PENRITH CITY COUNCIL

MAJOR ASSESSMENT REPORT

Application number:	DA20/0423
Proposed development:	Alterations and Additions to an Existing Dwelling and Change of Use to a Community Facility with Associated Car Parking & On-Site Waste Water Management System
Property address:	682 Castlereagh Road, AGNES BANKS NSW 2753
Property description:	Lot 2 DP 252556
Date received:	13 July 2020
Assessing officer	James Heathcote
Zoning:	RU1 Primary Production - LEP 2010
Class of building:	Class 9b
Recommendations:	Refuse

CAR PARK 1 (FRONT)- FLOOR PLAN 1:500

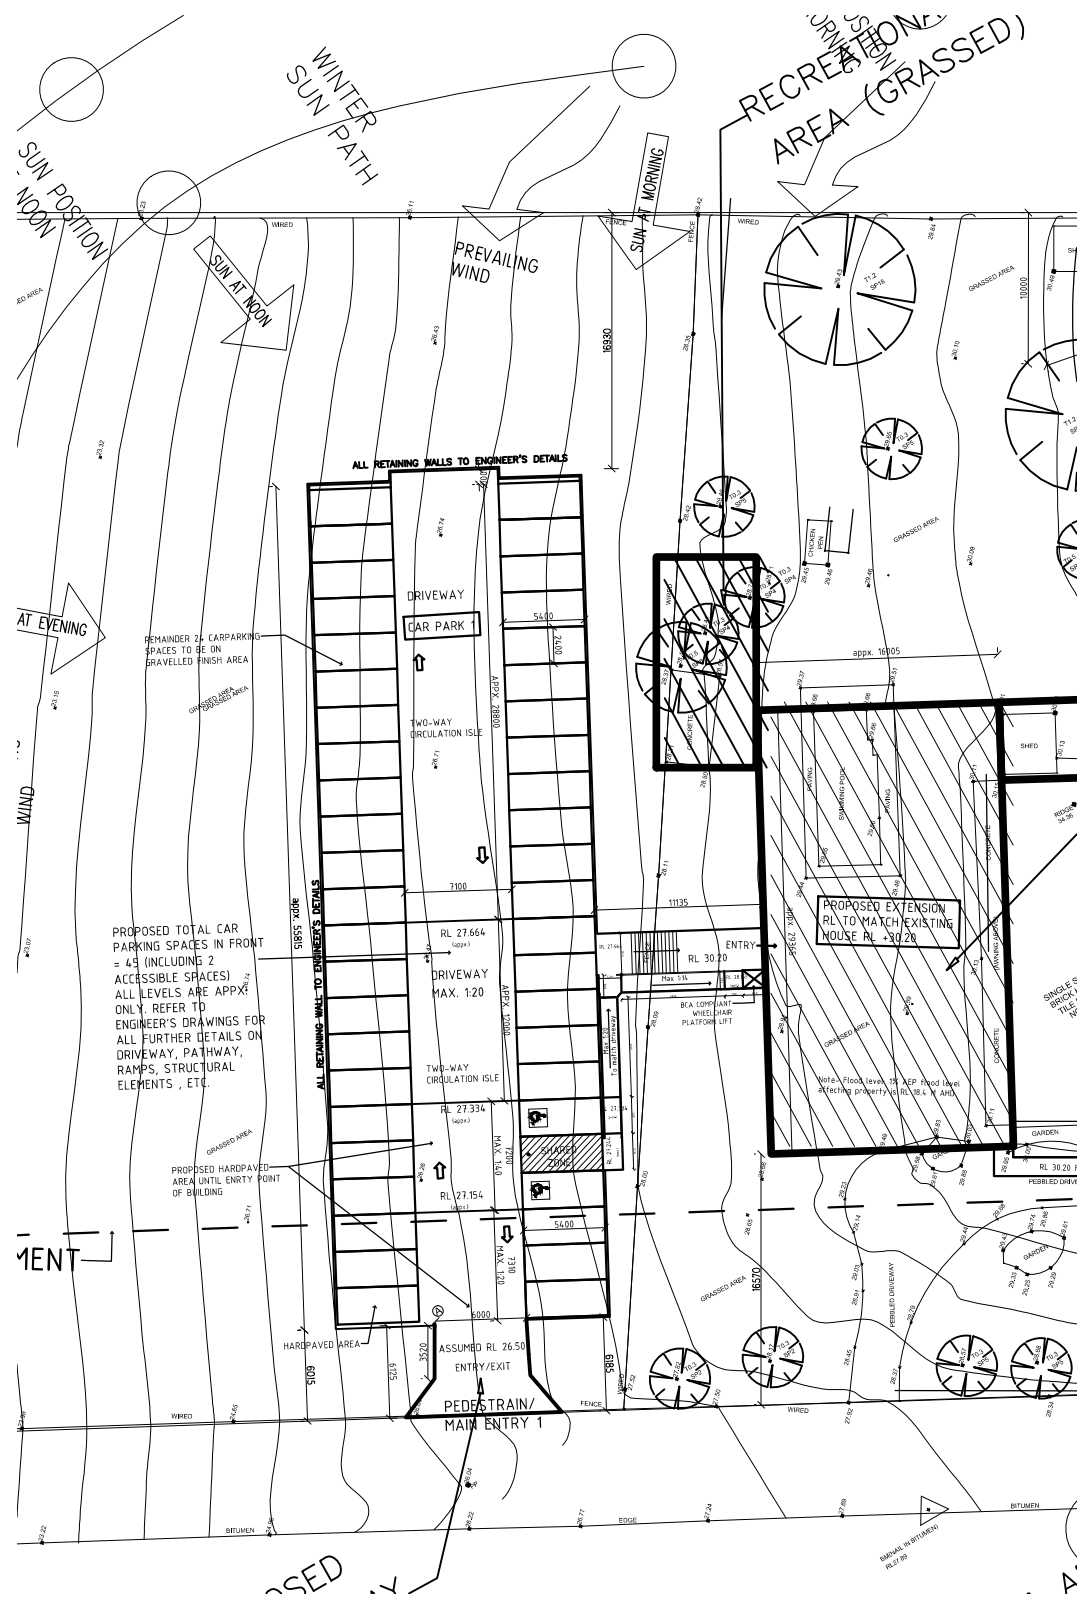
1. There is a difference in the finished surface level of carpark area 1 on the architectural, landscape and stormwater concept plans. The plan sets must be consistent with each other.

2. All parking spaces must allow for full opening of vehicle doors in accordance AS2890.1 for User Class 2 with a minimum space width of 2.5m.
3. All parking areas must be sealed and constructed of hard standing material in accordance with Penrith DCP 2014 [although this raises visual impact concern from a Planning perspective].

CAR PARK 2 (REAR)- FLOOR PLAN 1:500

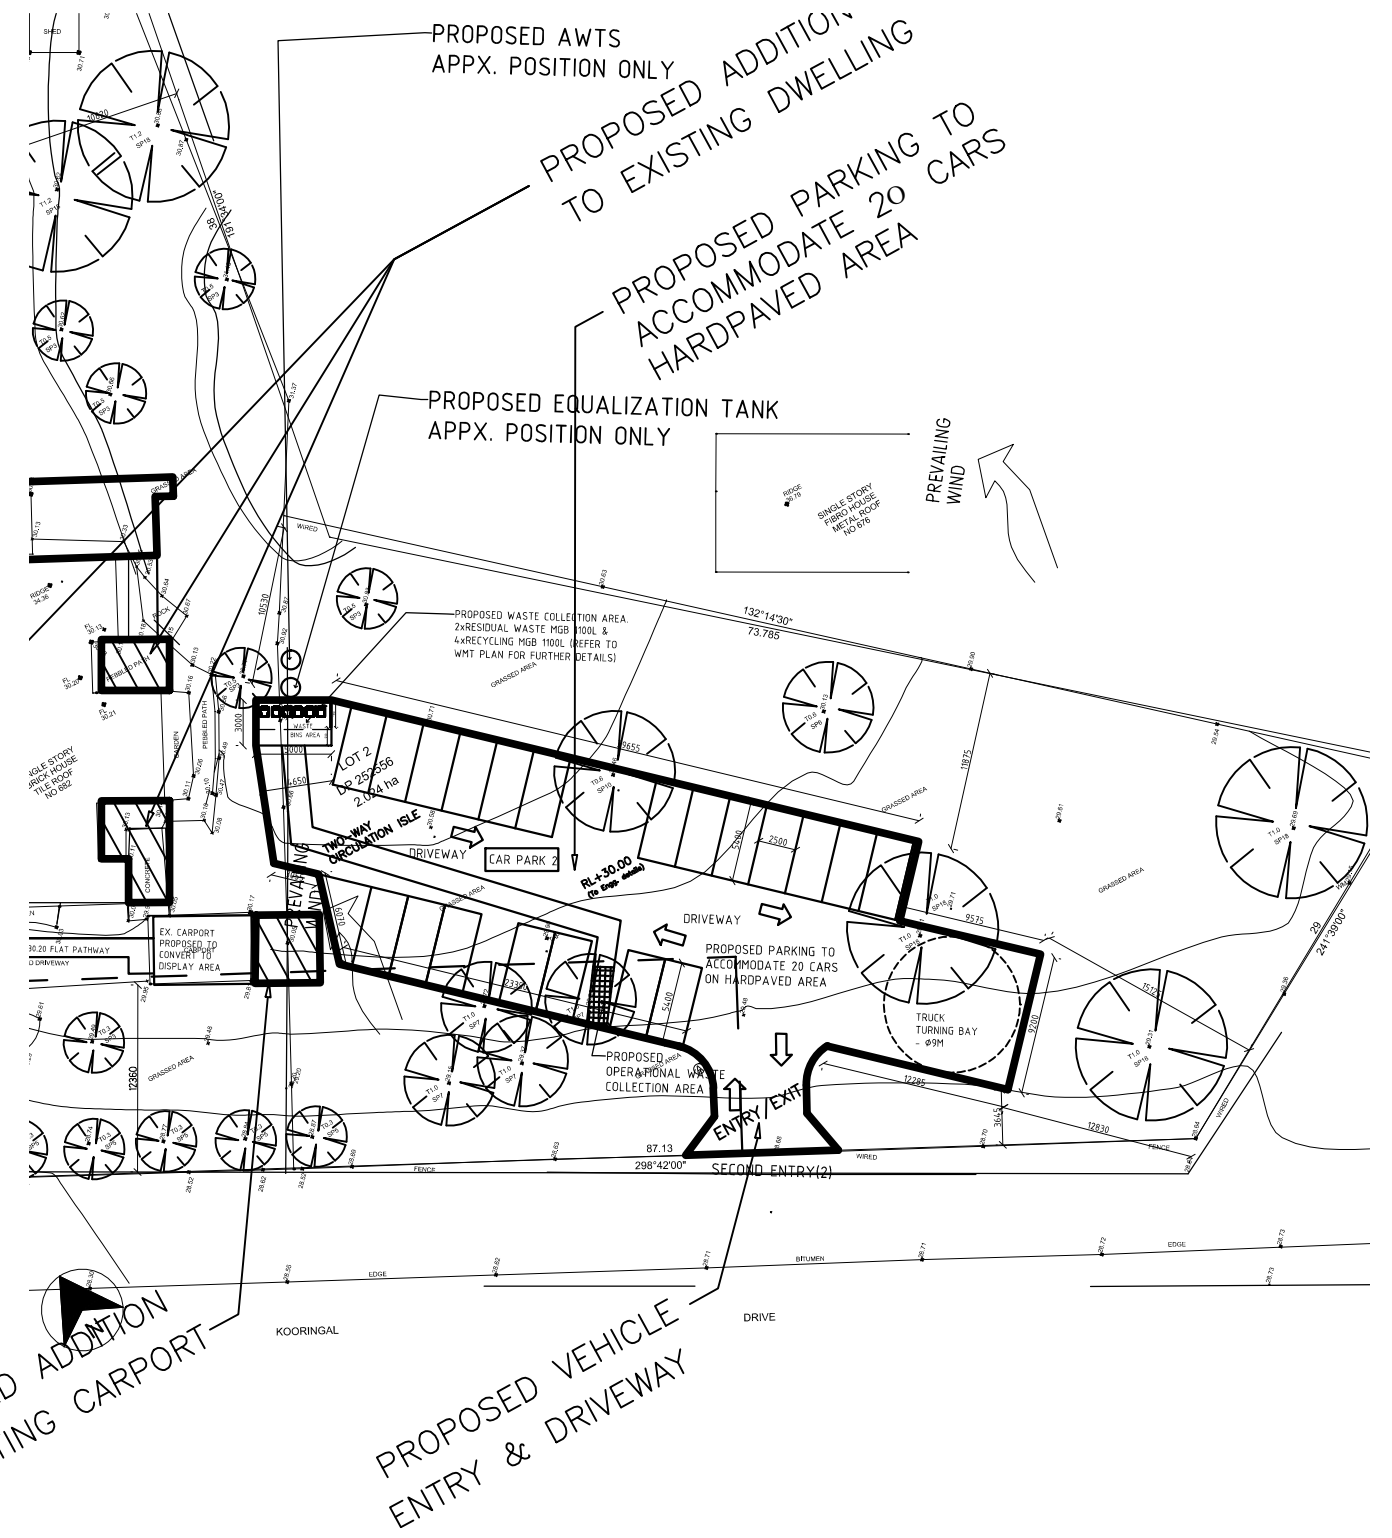
5. The parking aisle width of carpark 2 must be indicated on the plans in accordance with AS2890.1.
6. The proposed 1.8m high colorbond fencing on the northern boundary is located within the extent of the 1% AEP overland flowpath. The colorbond fencing must be replaced with an open style fencing for a distance of 75m from the north-western corner of the property.
